# Access Compliance Report

## Public Rights-of-Way

Intersection ID: 11839	Main Street: FLEETWOOD_DR	Cross Street: EVERGREEN_DR	Location: NE
ADA ID: C1E706E82E92	Ramp Type: Perp	Initial Pass/Fail: Fail	Overall Compliance: No
Severity Score: 25			
Codes/Mitigation Info/Possible Solution		Field Measurements/Component Compliance

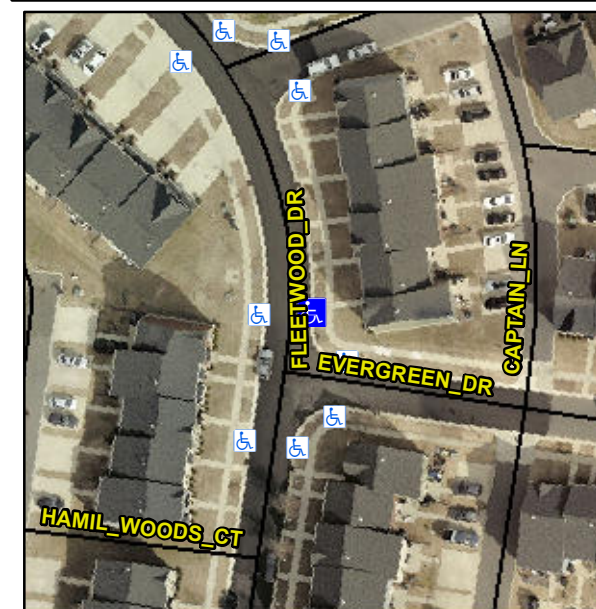
**Not Found, R304.2.2, R304.5.3**

Compliance	Description	Data	Compliance	Description	Data
N/A	Ramp Length (in)	72.5	No	Ramp Slope (%)	8.6
Yes	Ramp Width (in)	48.0	No	Ramp XSlope (%)	5.6
N/A	Flare Type LT	N/A	N/A	Flare Type RT	N/A
N/A	Flare Slope LT (%)	N/A	N/A	Flare Slope RT (%)	N/A
N/A	Flare Traversable LT?	N/A	N/A	Flare Traversable RT?	N/A
N/A	Landing Length (in)	N/A	N/A	DWS Provided?	N/A
N/A	Landing Width (in)	N/A	N/A	DWS Contrast?	N/A
N/A	Landing Slope (%)	N/A	N/A	DWS Length (in)	N/A
N/A	Landing X Slope (%)	N/A	N/A	DWS Full Width?	N/A
N/A	Landing Curb? (Y/N)	N/A	N/A	DWS Offset (in)	N/A
N/A	Shared Landing?	N/A			
N/A	Gutter Ponding?	N/A	N/A	Gutter Slope (%)	N/A
N/A	Gutter Lip Ht (in)	N/A	N/A	Gutter X Slope (%)	N/A
N/A	Painted X Walk1?	No	N/A	Painted X Walk2?	N/A
	X Walk 1 Direction	To W		X Walk 2 Direction	N/A
N/A	X Walk 1 Width (in)	N/A	N/A	X Walk 2 Width (in)	N/A
	X Walk 1 Slope (%)	4.5		X Walk 2 Slope (%)	N/A
	X Walk 1 X Slope (%)	5.4		X Walk 2 X Slope (%)	N/A

**Remove & Replace Entire Ramp.**
